P02	19/05/23	Response to RFI	
P01	29/04/22	Issued For Planning	
Revision Number	Date	Drawn	Details of Issue / Revision
Issues & Revisions

Project Details:
 Dalguise
 Monkstown

Drawing Title:
 Proposed Elevations and Sections - Block F + G

MKS-RAU-FG-ZZ-DR-AR-200

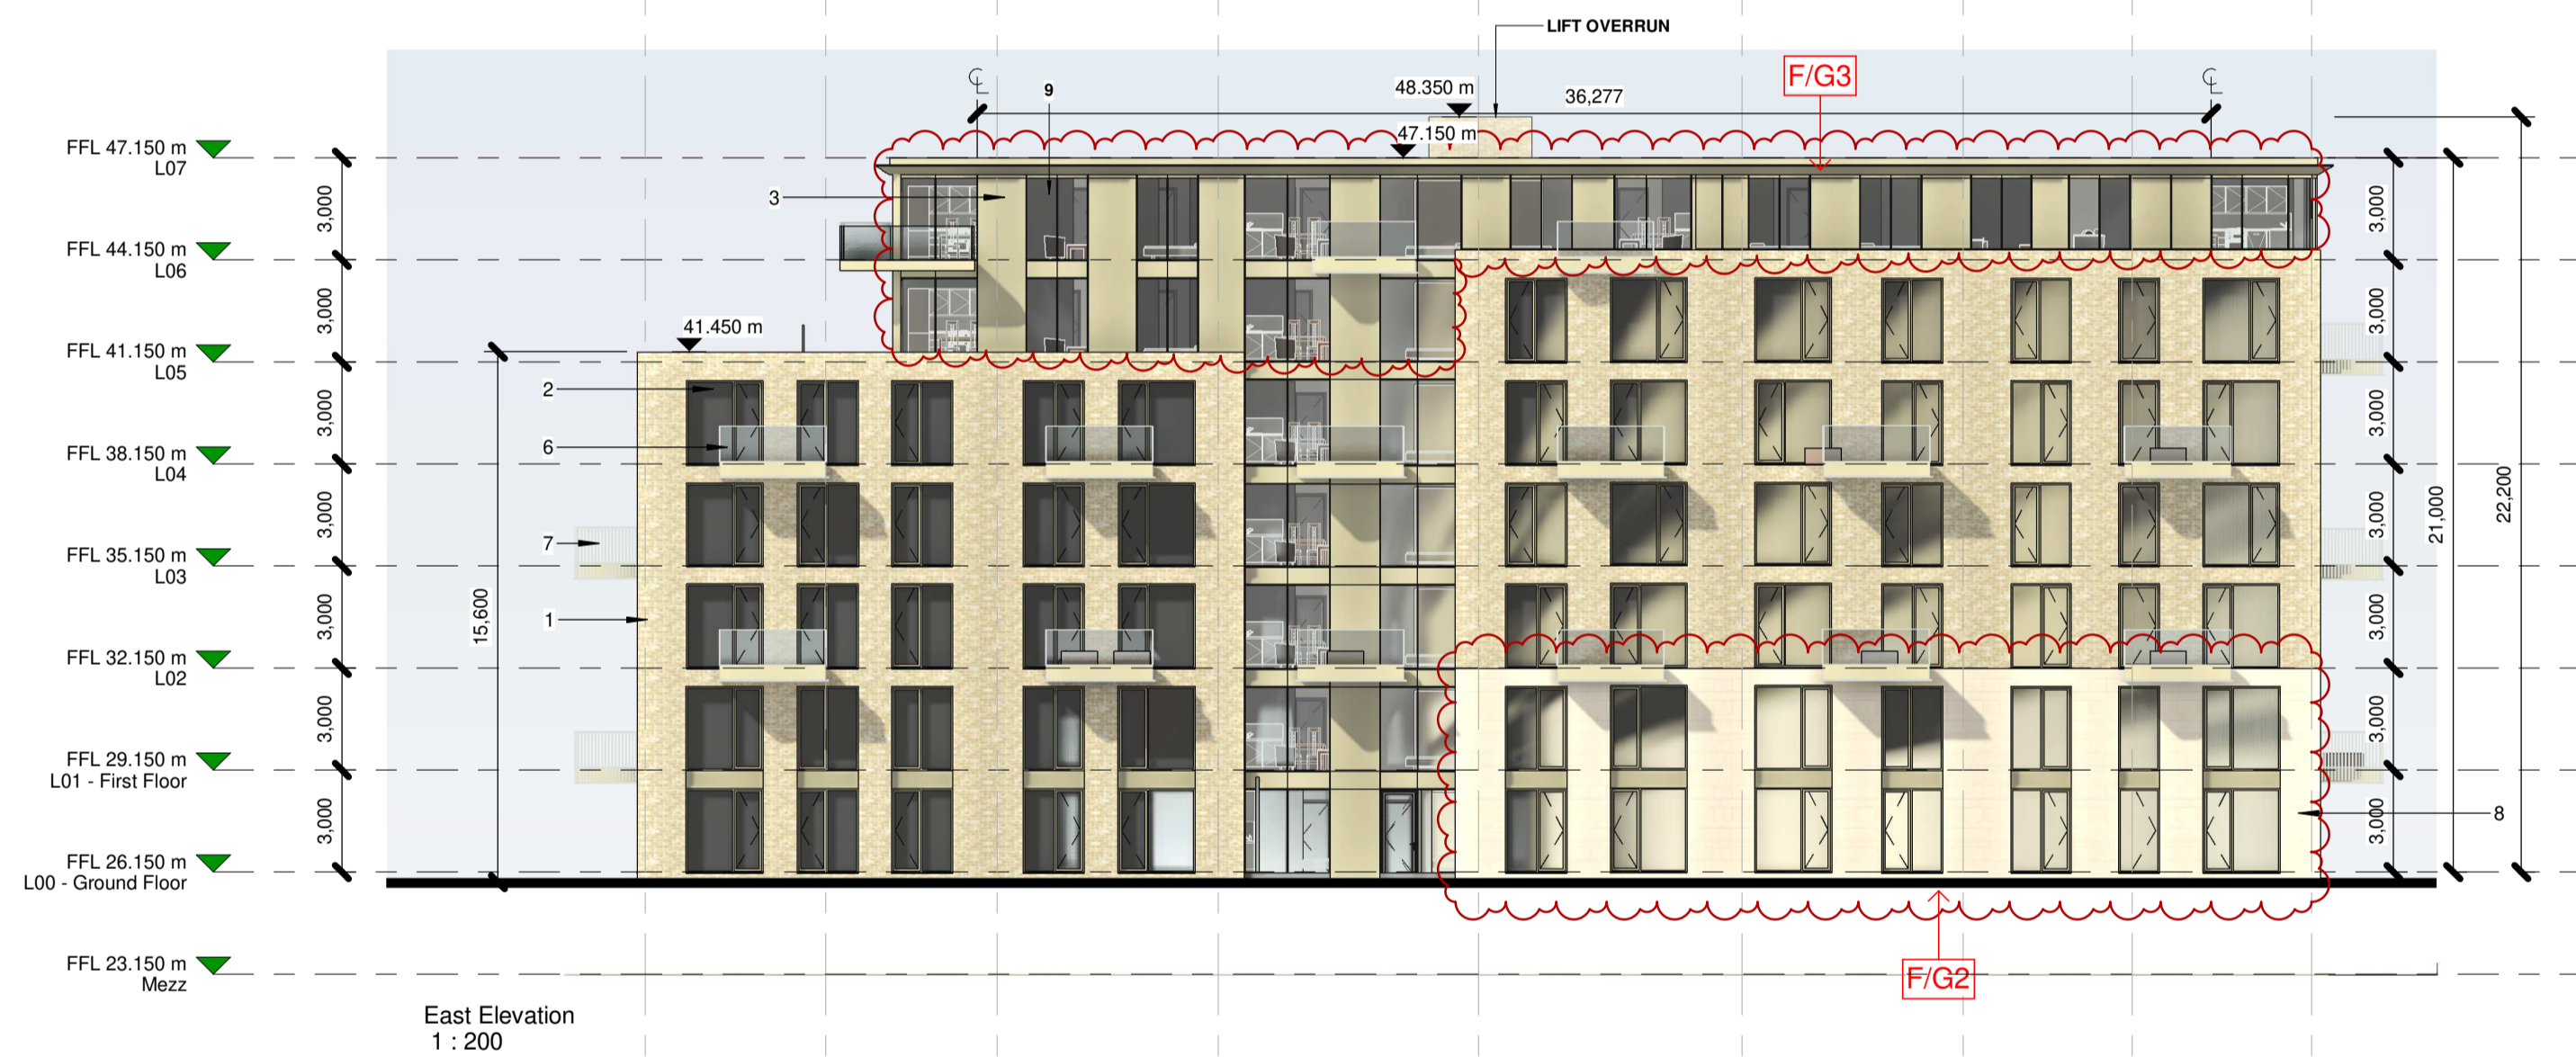
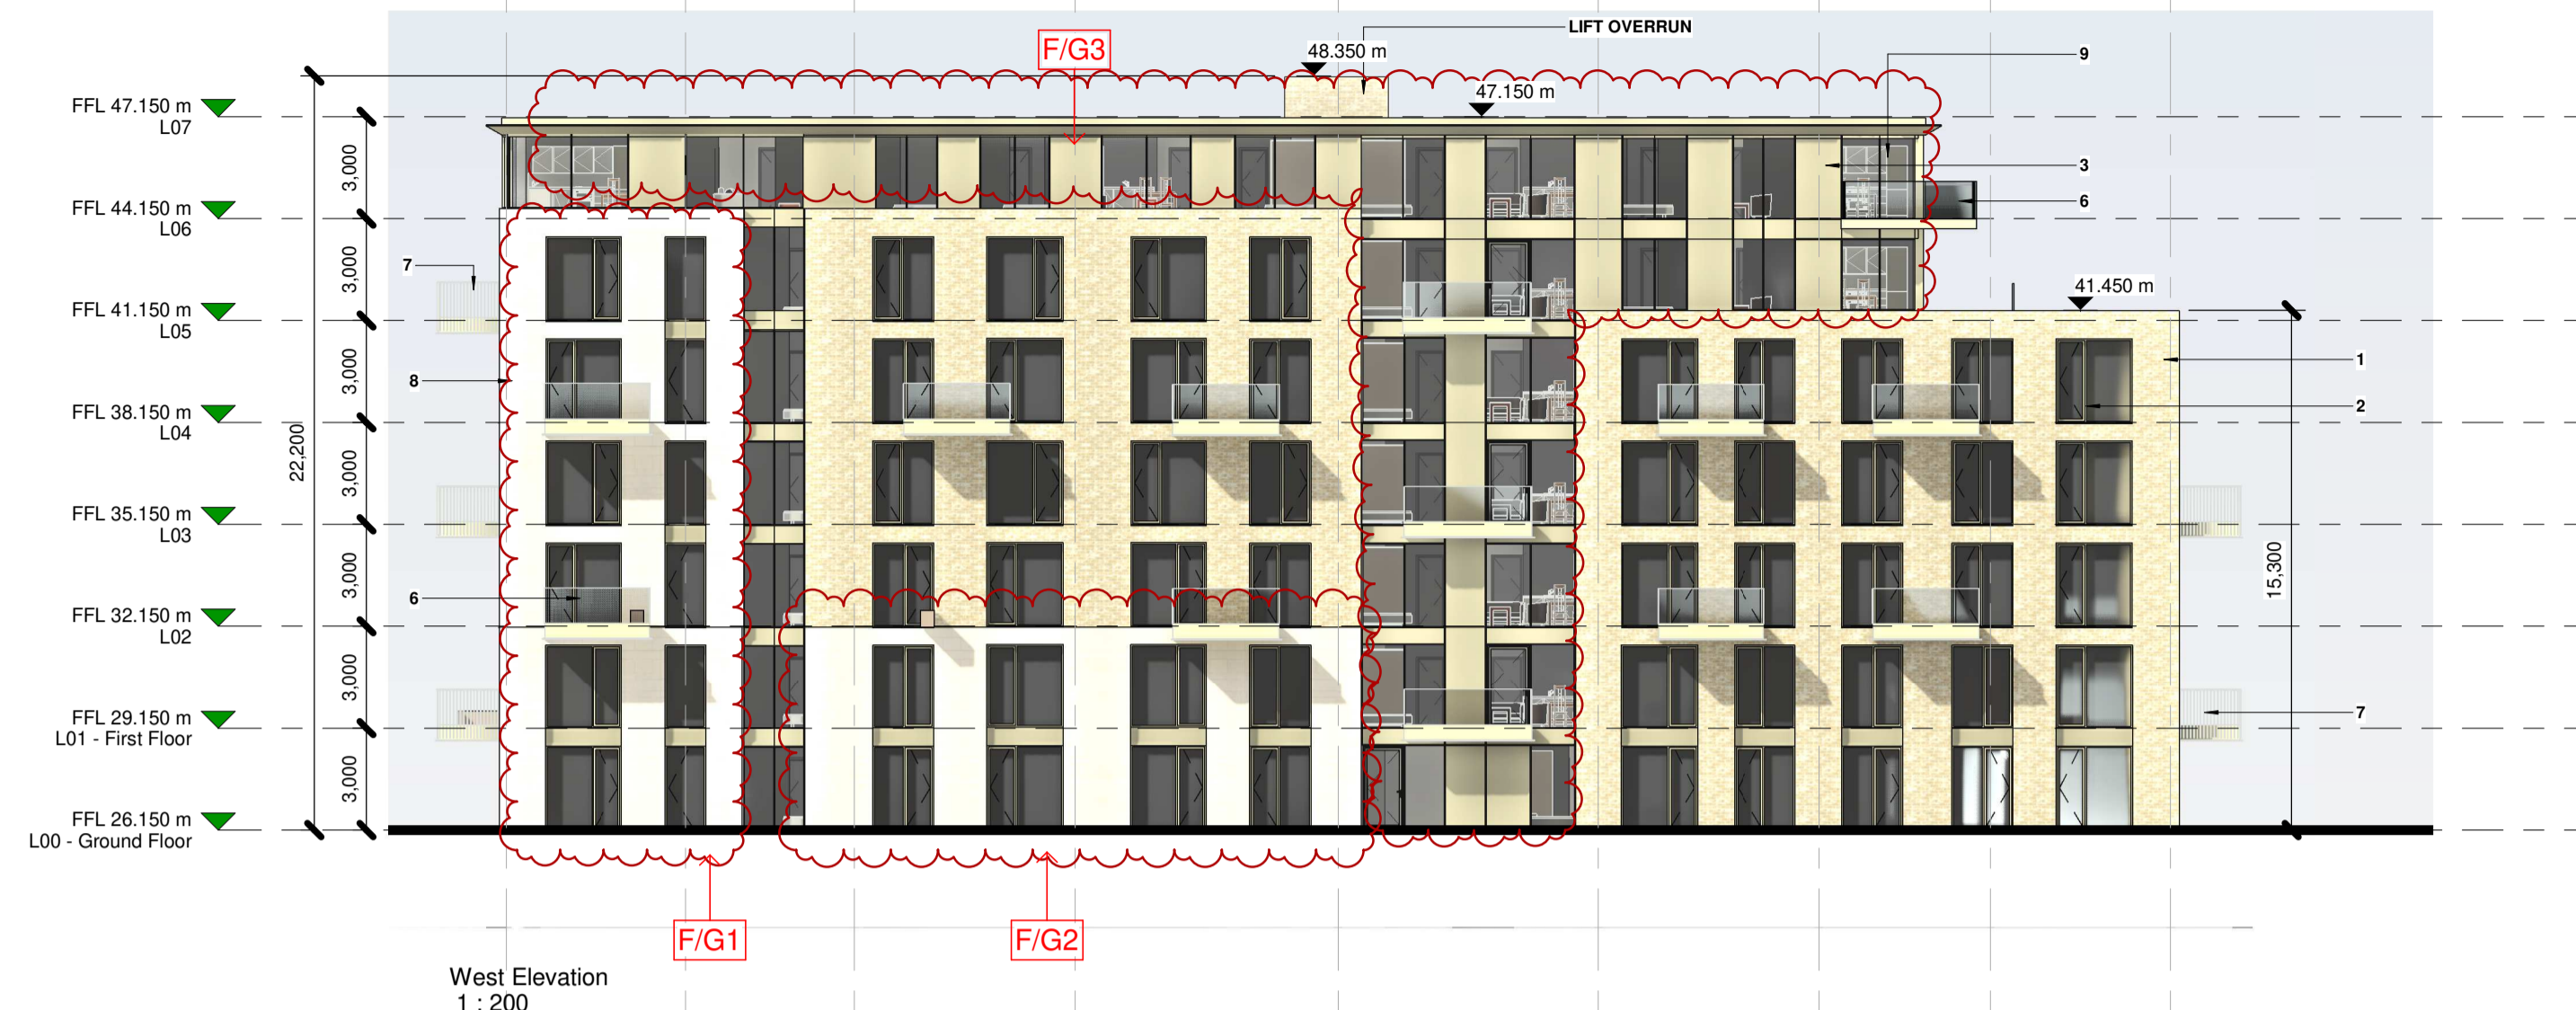
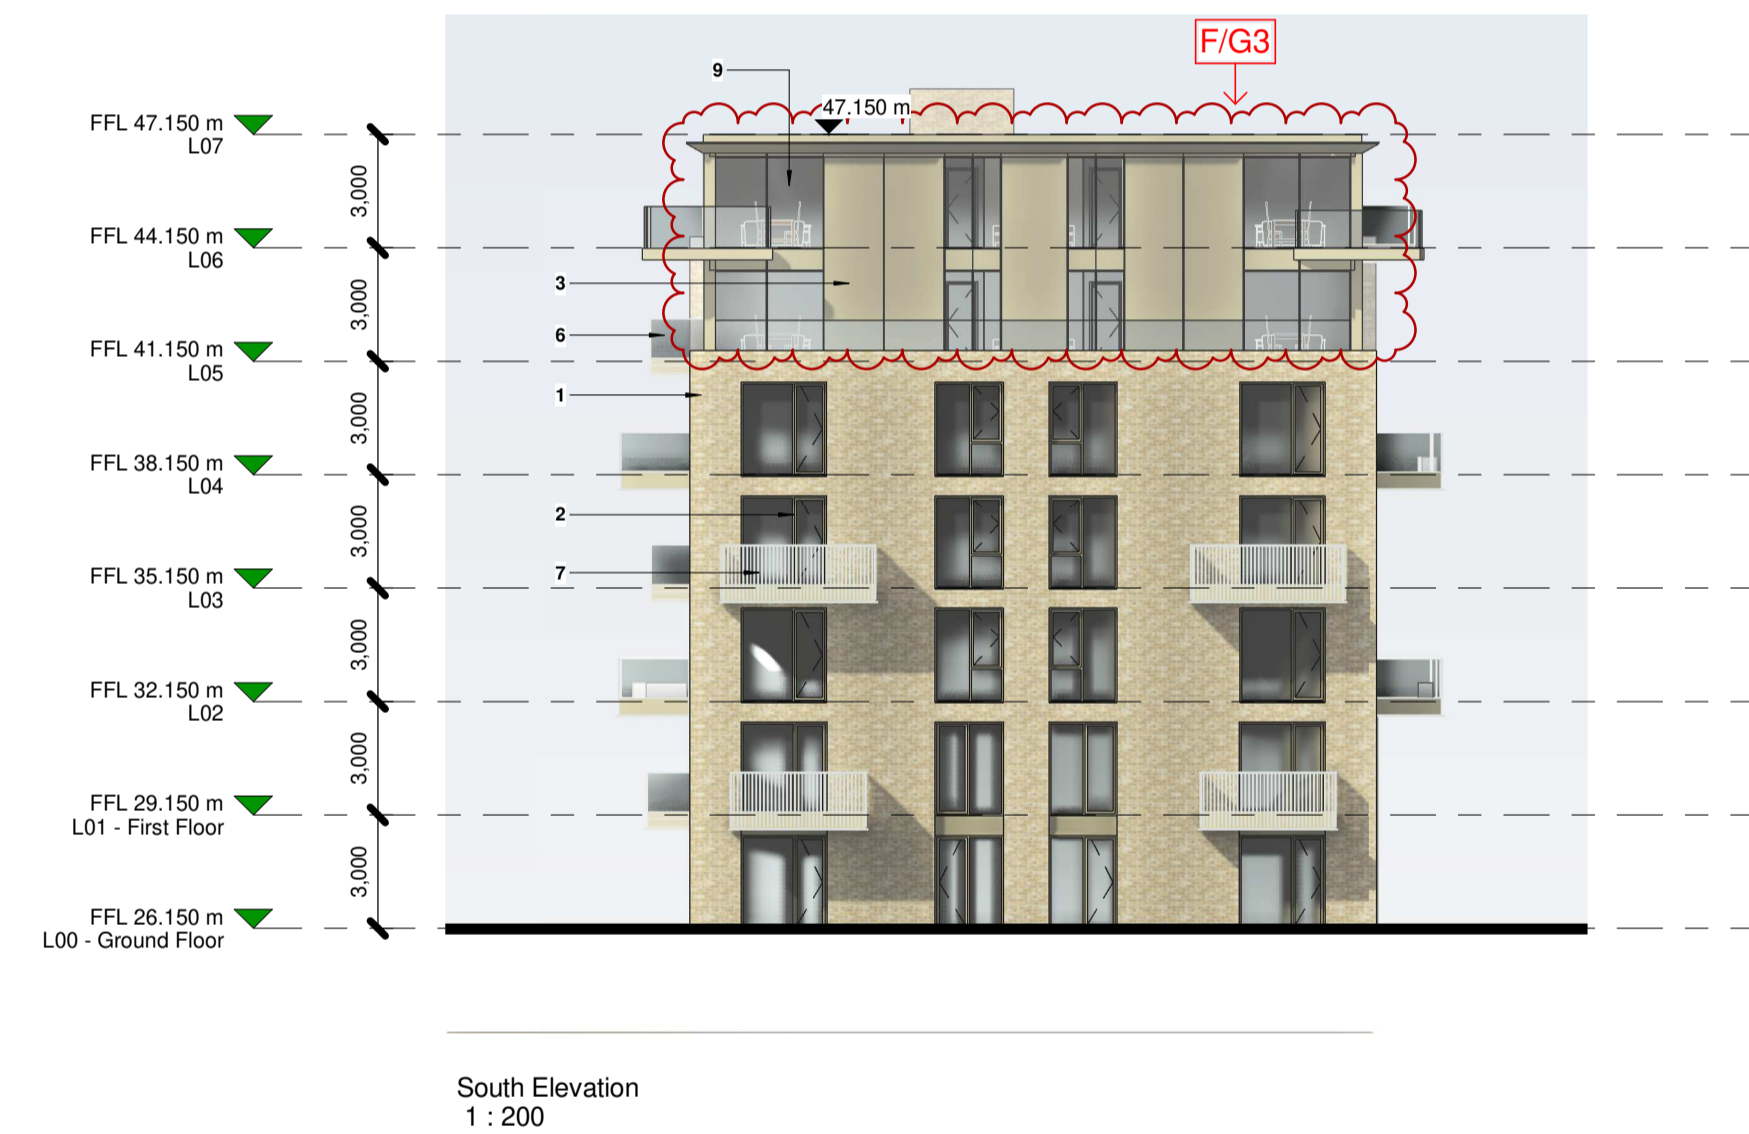
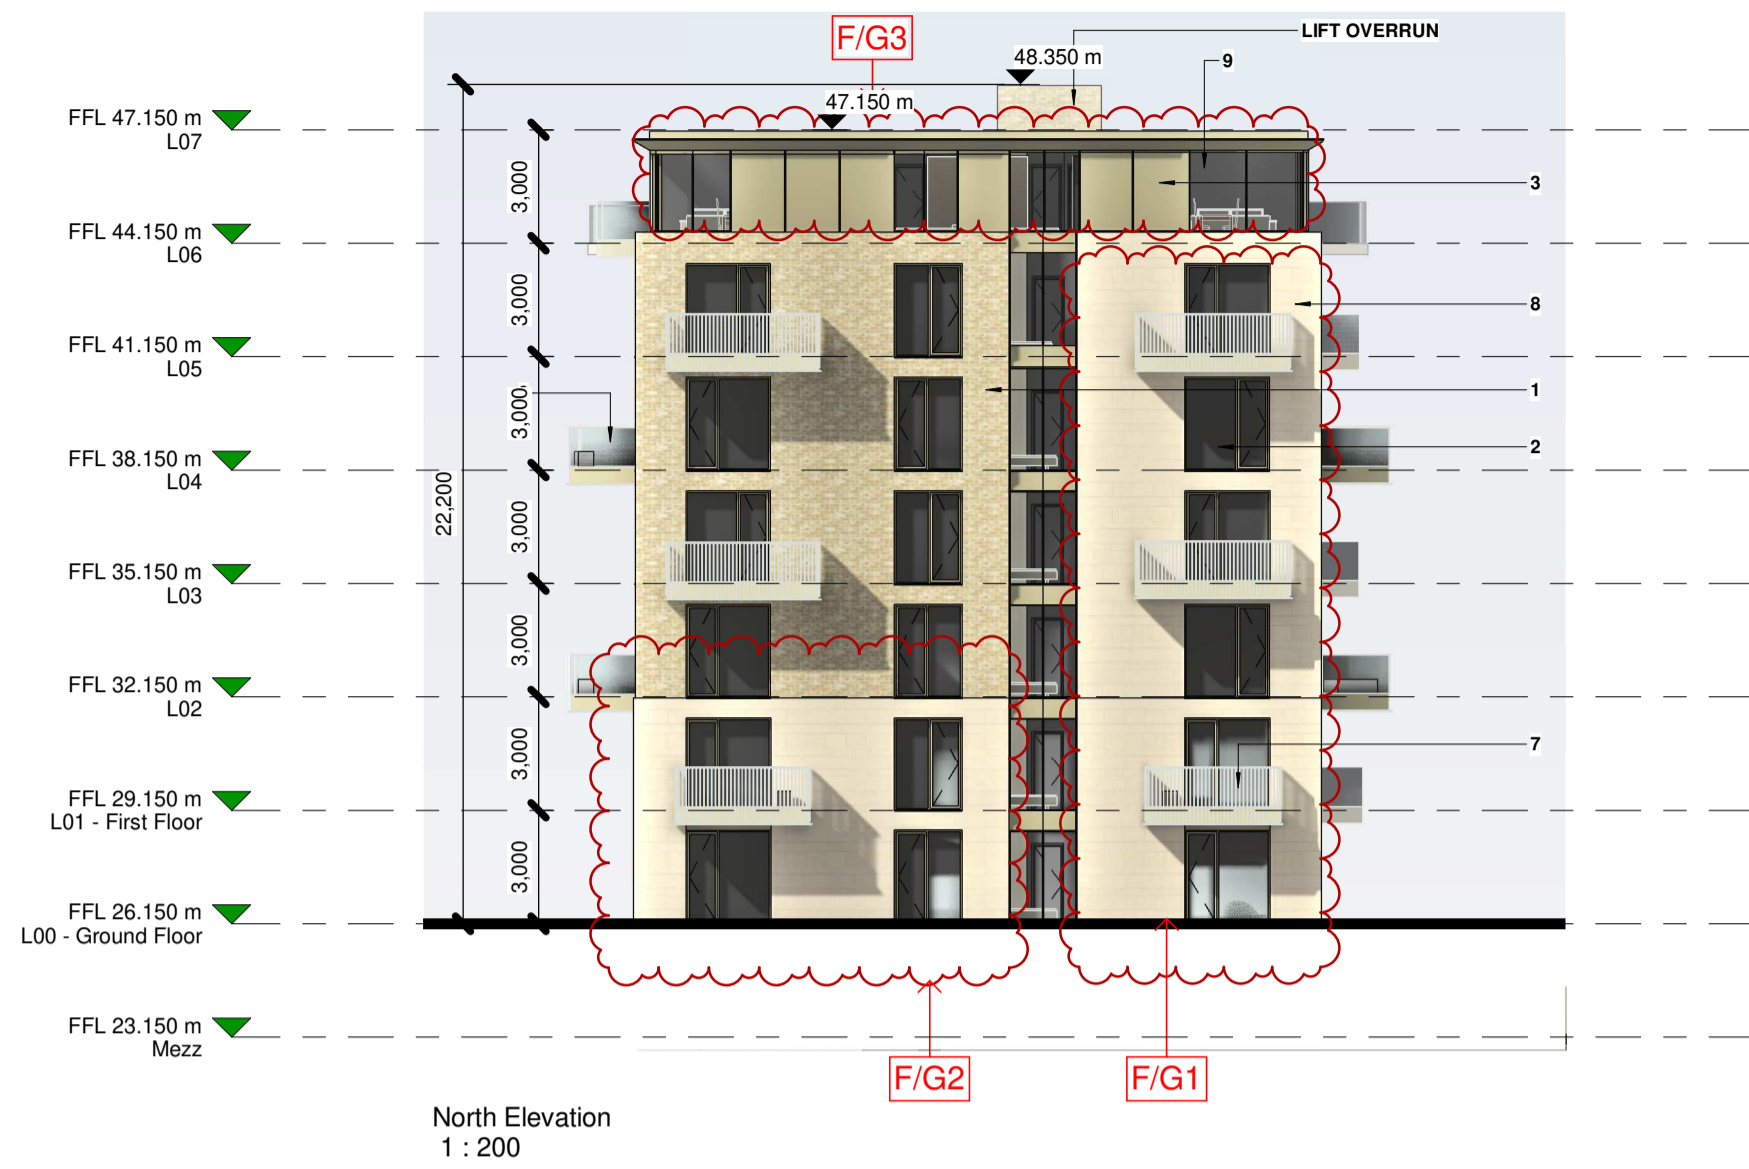
F/G1. Stone added to North East Corner of Building.

F/G 2 Stone Base added to Building - Ground to First floor forming a base plinth.

F/G 3. Tone of metal set back floor amended.
